MONOLITHIC GLASS PERFORMANCE DATA

WEBSTER UNIVERSITY ISB
PROJECT NAME

RE: Stair 1 Glass For Handrail Product Data

RE: Glass handrail Samples

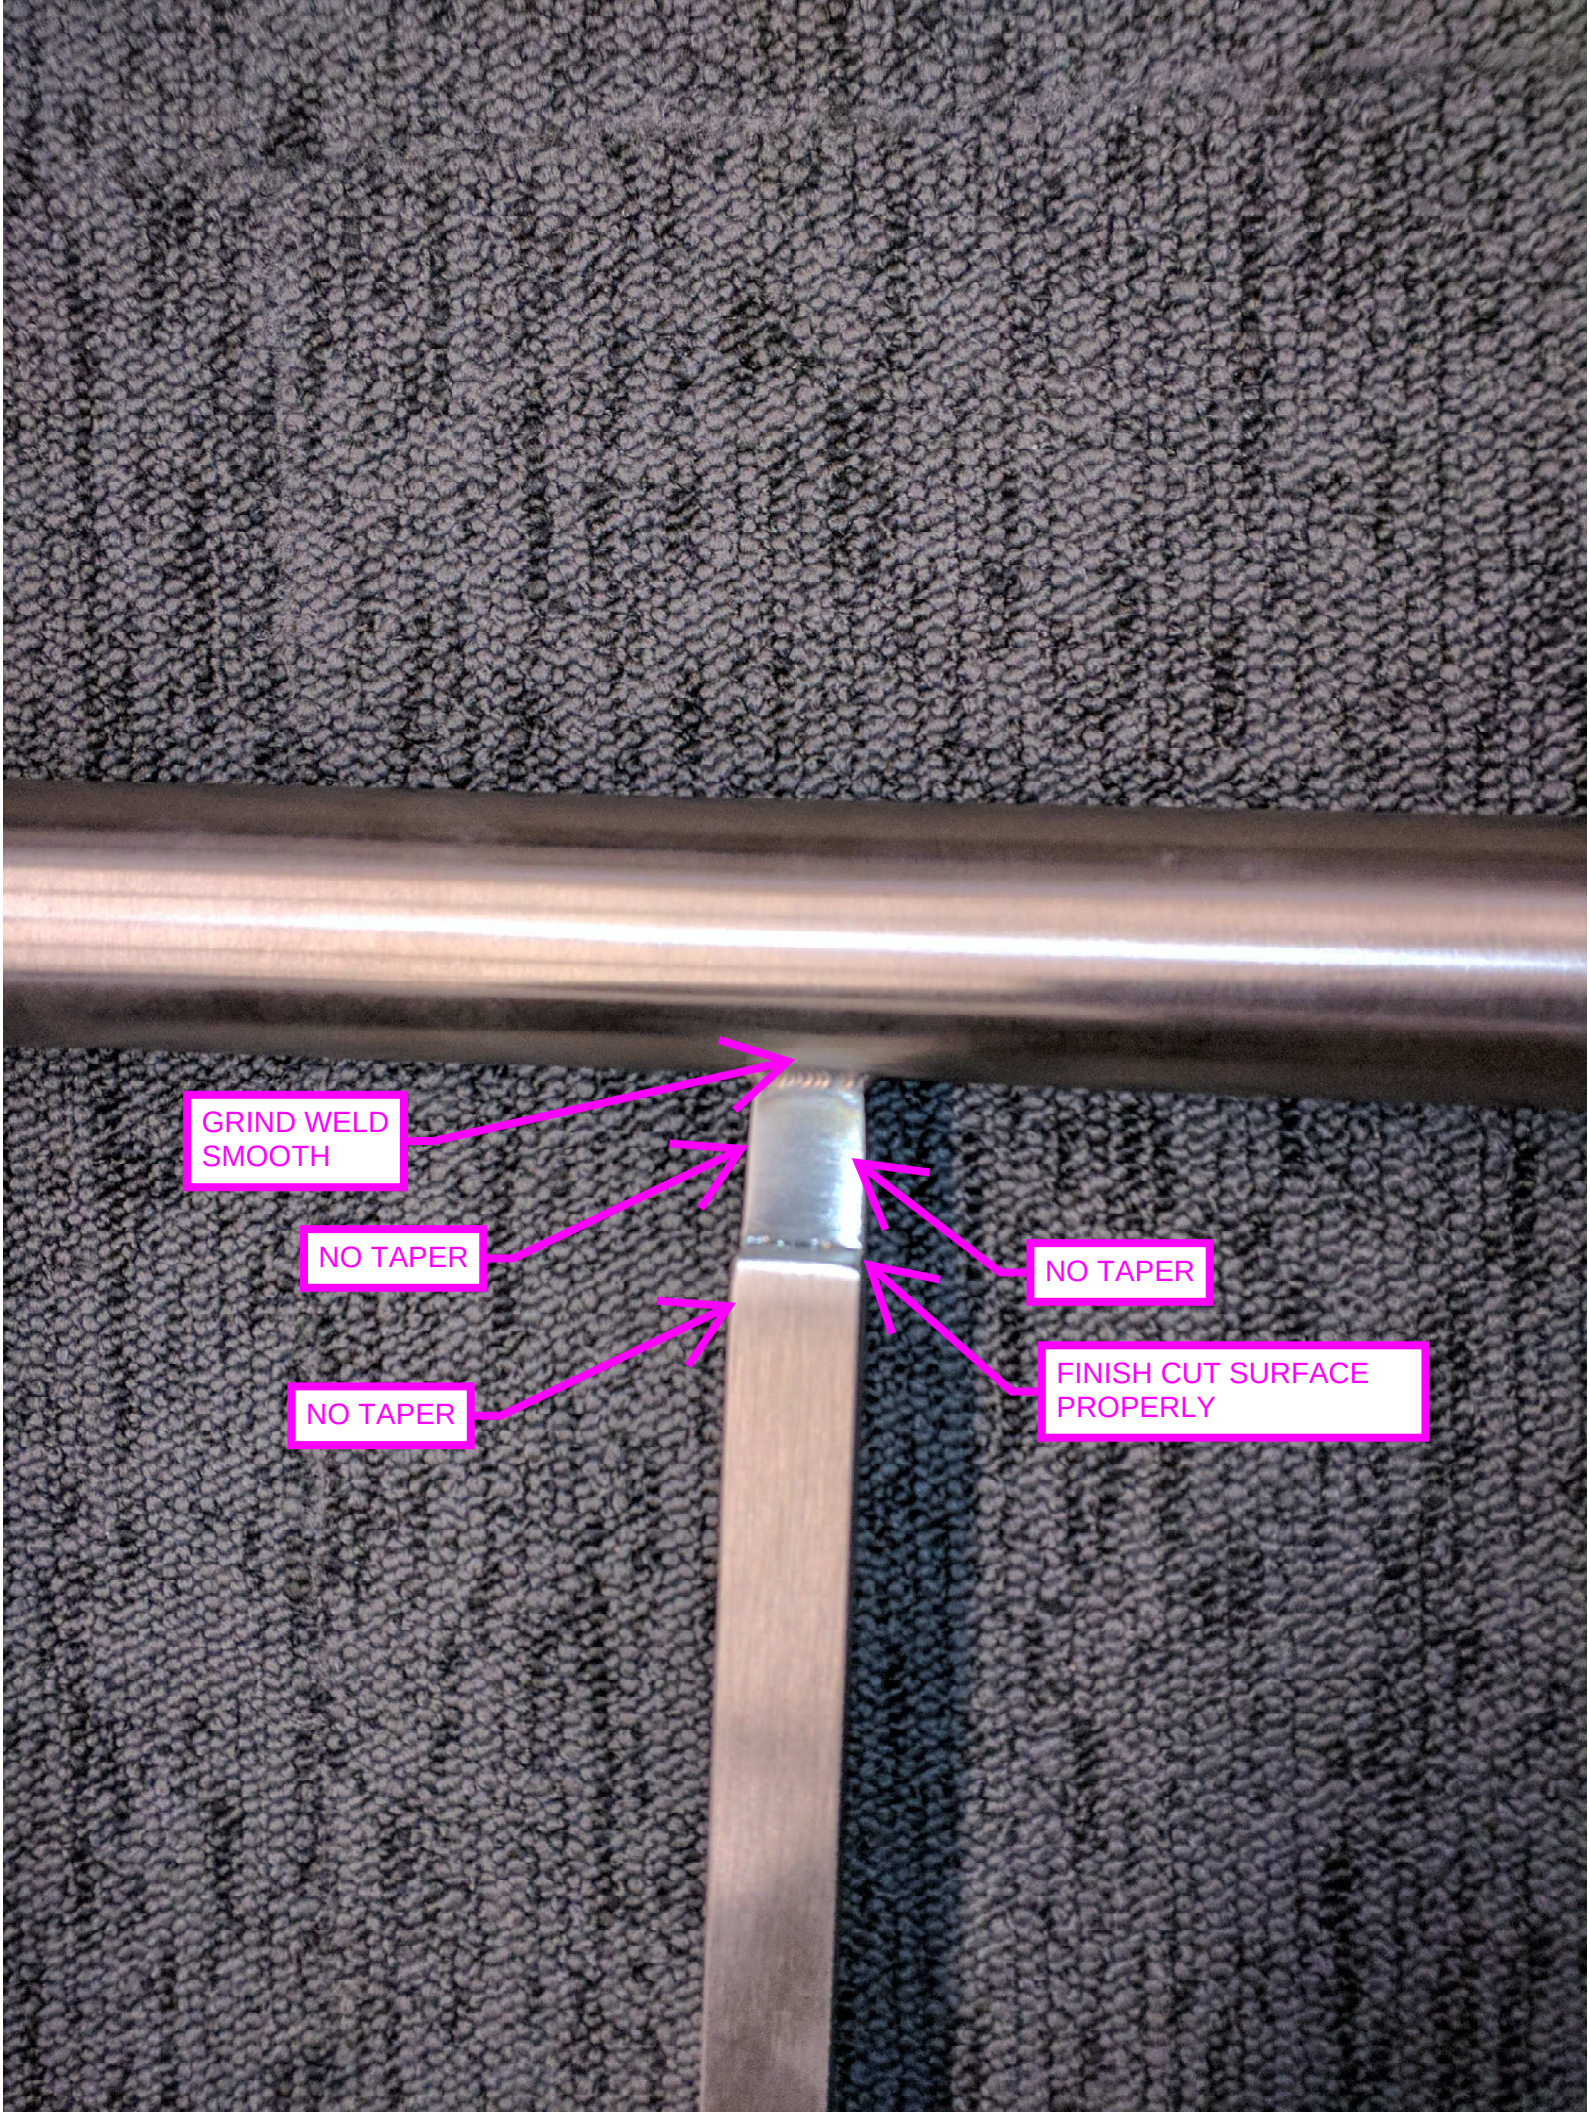
FREE STANDING POST RAILING: (MCN)
-Grind weld smooth.
-No discoloration due to welding burn should be visible. Polish to match finish.
-Bar appears to taper due to excessive grinding.
-No tapering should occur.
-All cuts to be properly ground and polished.
DISCOLORATION
GRIND WELD SMOOTH
NO TAPER
NO TAPER

DISCOLORATION
GRIND WELD SMOOTH
STRAIGHT CUT
NO TAPER

GRIND WELD SMOOTH
NO TAPER
NO TAPER
NO TAPER
FINISH CUT SURFACE PROPERLY

Oldcastle BuildingEnvelope®
Warrenton, MO (636) 456-3452
Customer: FOREMAN FABRICATORS ATTN TIM LOVELL
Project: SGP LAMI
Order # 104818
Makeup: 3/8" CL - 060SG--3/8" CL - **POLISH 1 LONG**
Oldcastle BuildingEnvelope makes no warranty by this sample.
Annealed samples are for color evaluation only

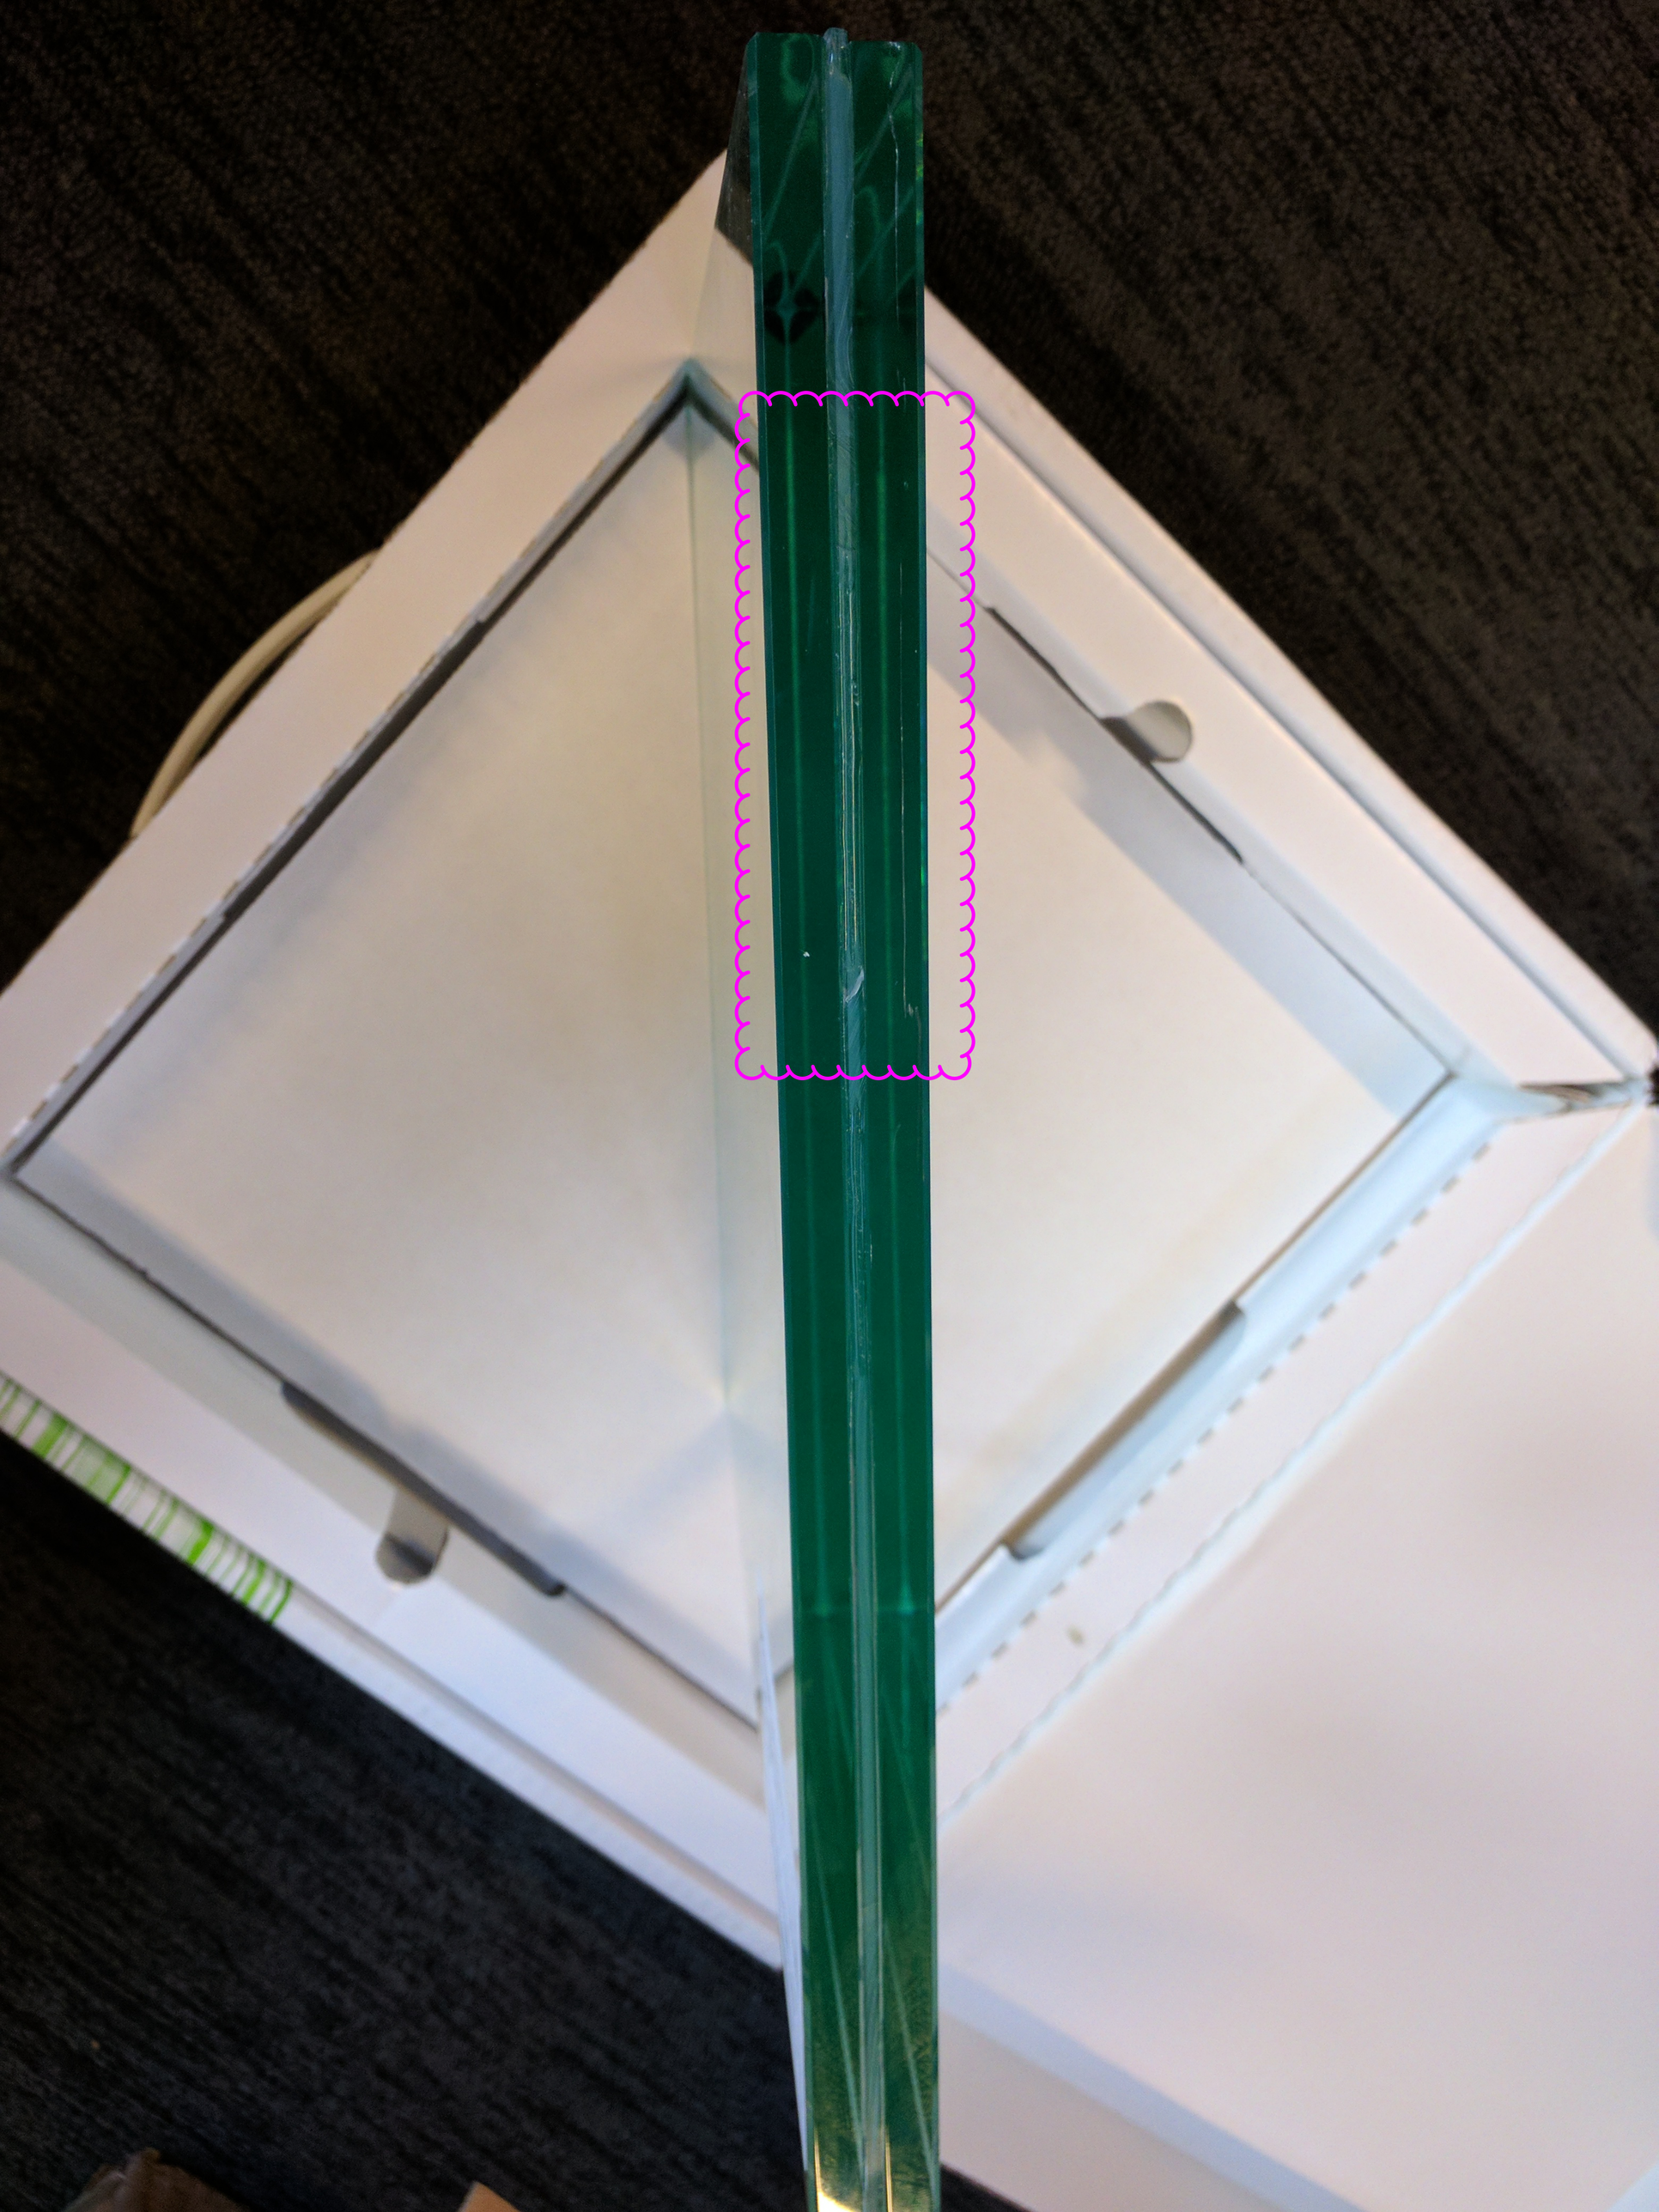
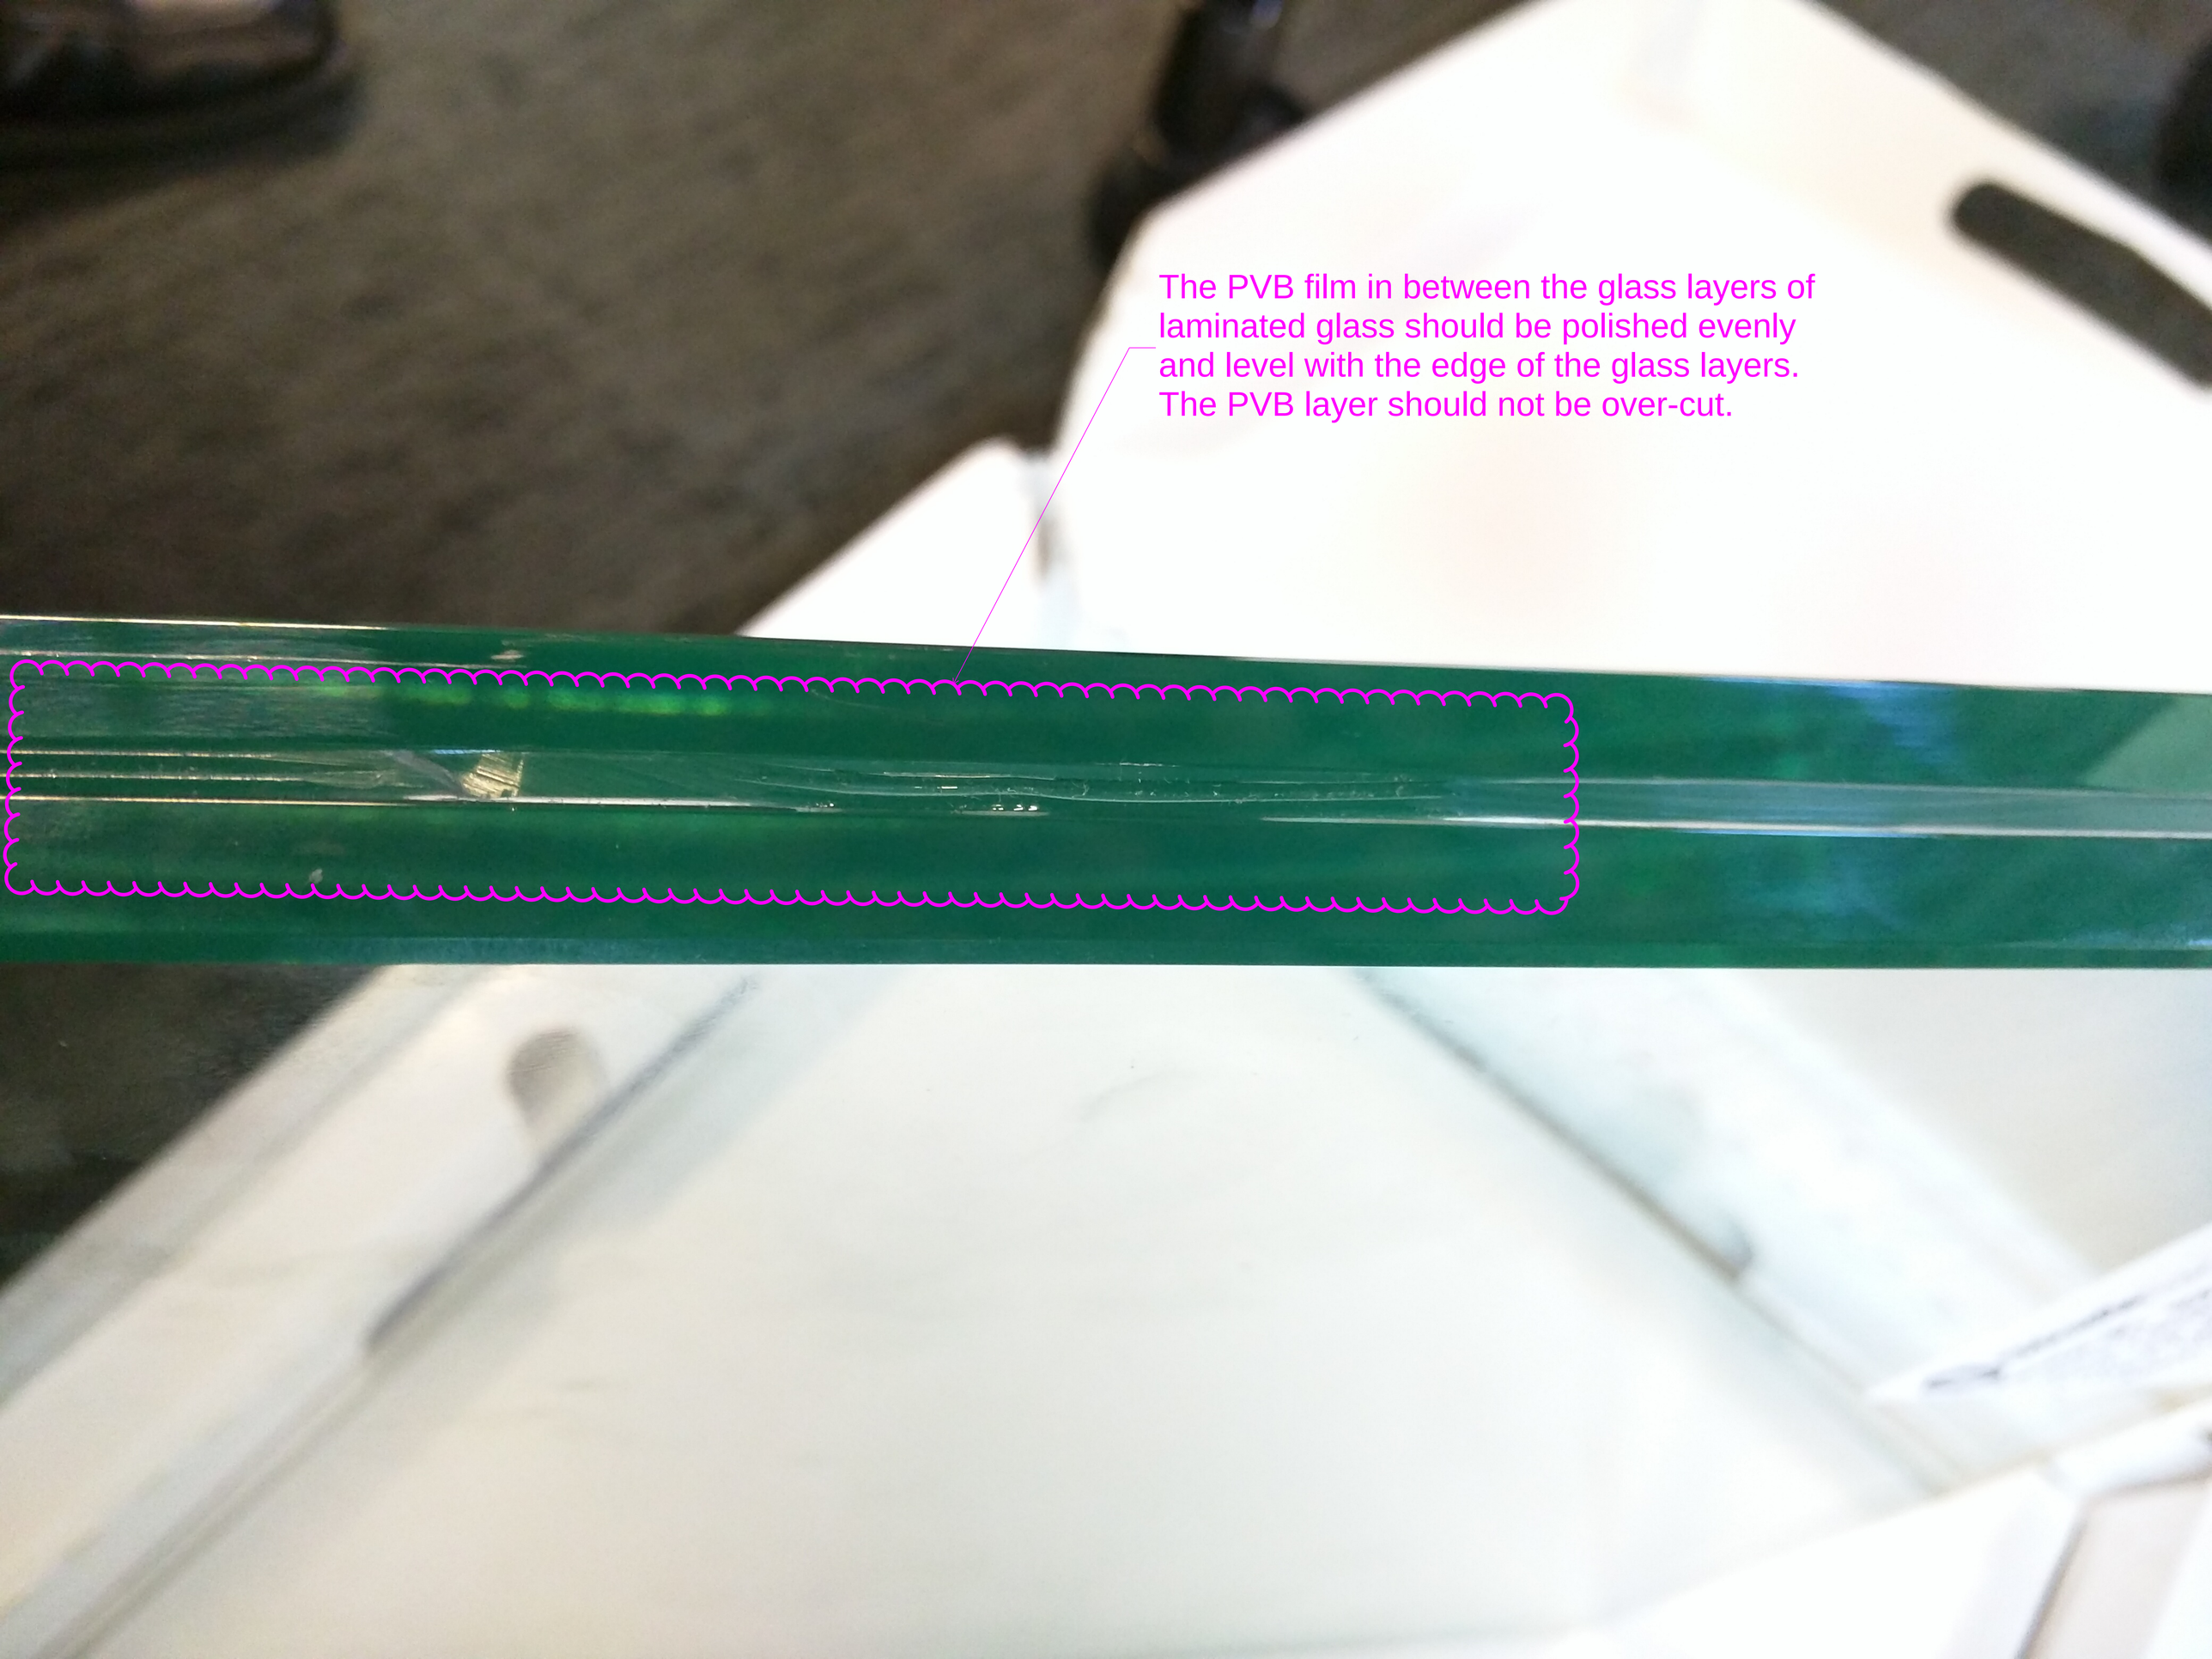
The PVB film in between the glass layers of laminated glass should be polished evenly and level with the edge of the glass layers. The PVB layer should not be over-cut.
